Southern California Edison Company

April 1, 1994

Subject: Docket Nos. 50-361 and 50-362  
Shutdown Technical Specifications  
San Onofre Nuclear Generating Station  
Units 2 and 3

## GENERIC REFUELING OUTAGE SCHEDULE (Existing)

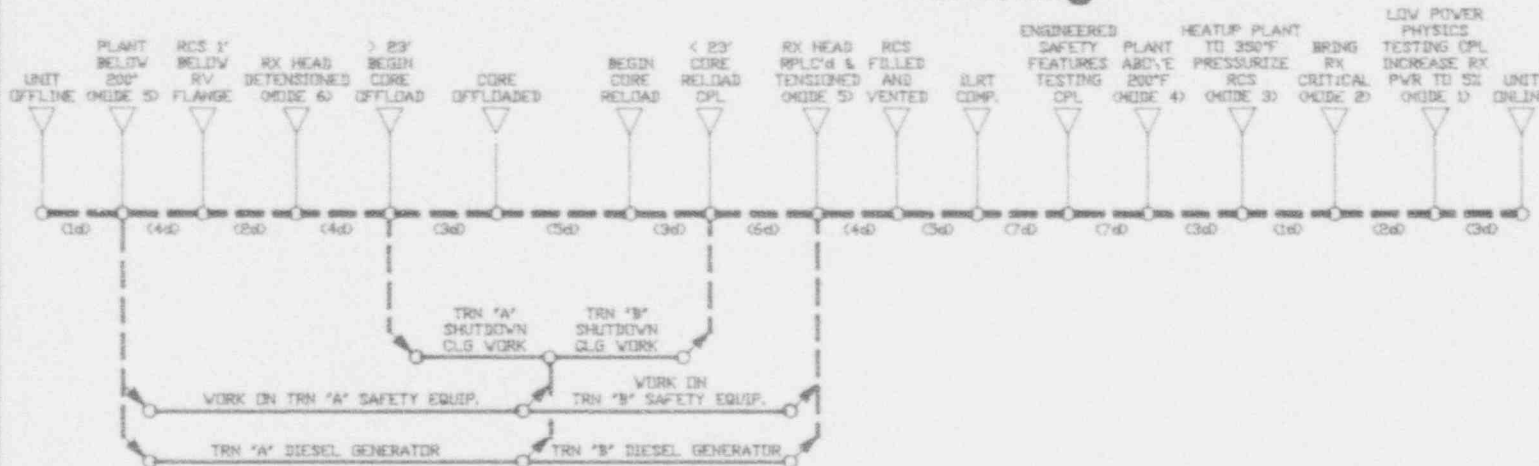
The negative impact of this proposed requirement would be that maintenance work on the emergency diesel generators, which typically begins prior to fuel offloading, would have to be postponed until the beginning of fuel offloading and would have to be completed prior to the completion of fuel reloading. This

would be necessary because this is the only time during the outage when the water level can be raised to greater than 23 feet above the vessel flange. As shown in the enclosed Generic Refueling Outage Schedule, the result would be an outage extension of 16 days. (This extension was understated by 6 days during the February 1 presentation.)
